MAP OF SURVEY

LOT No 27

MOCCASIN HILL

TOWN OF WAPPINGER
 SCALE: 1"=50'

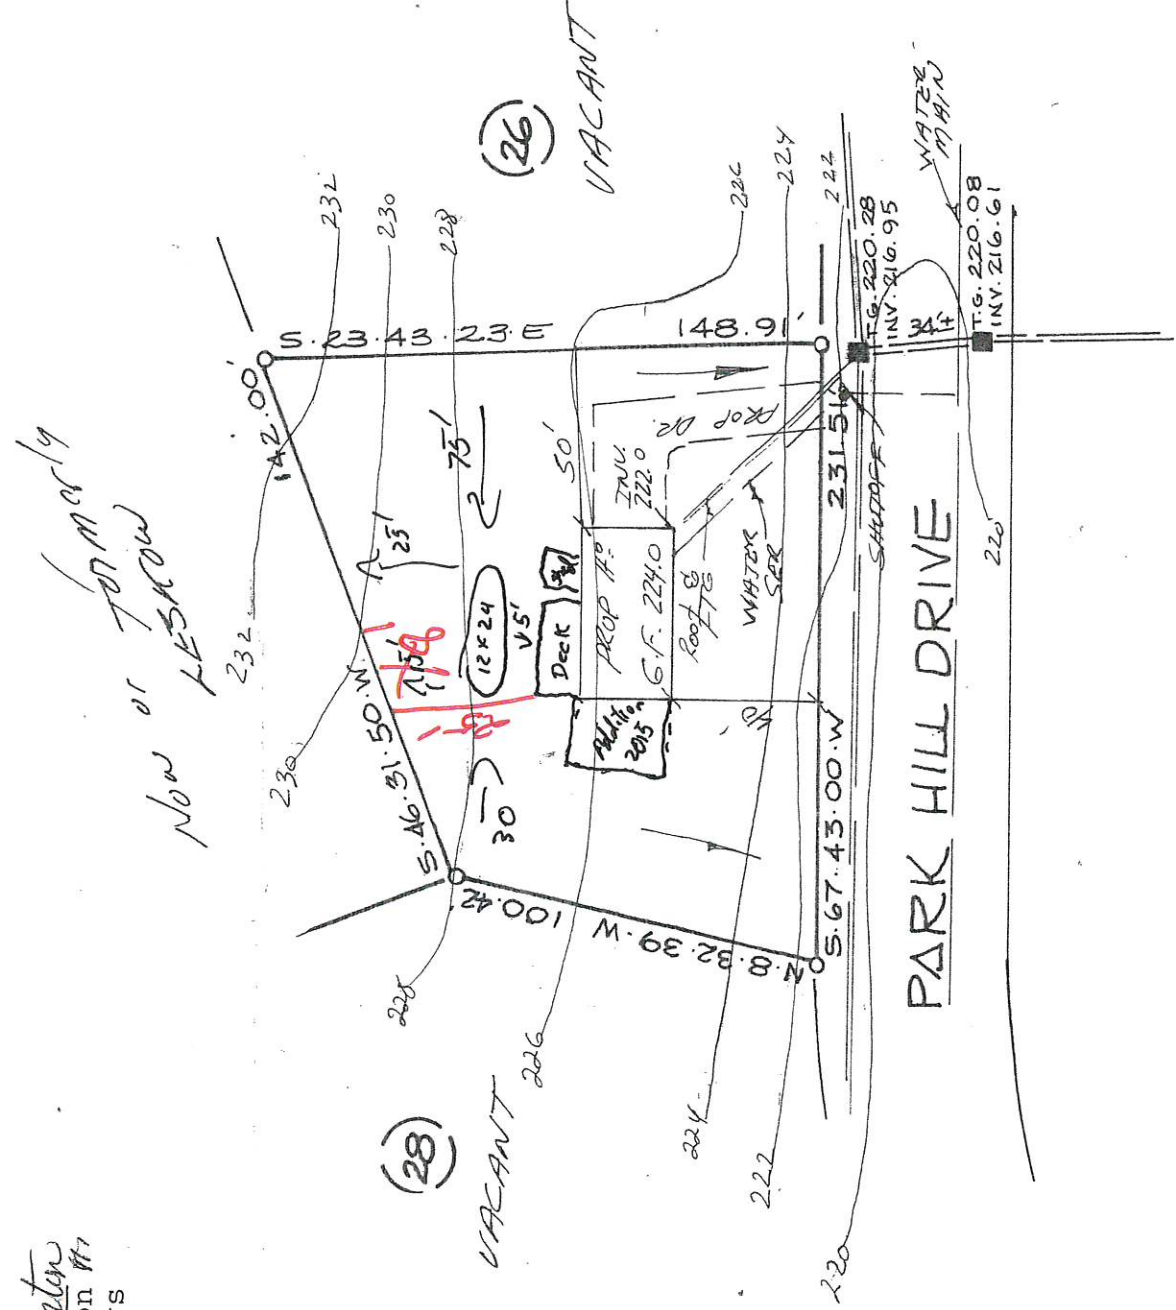
Approved 5/5/77, subject to:
 Driveway must be blacktopped.
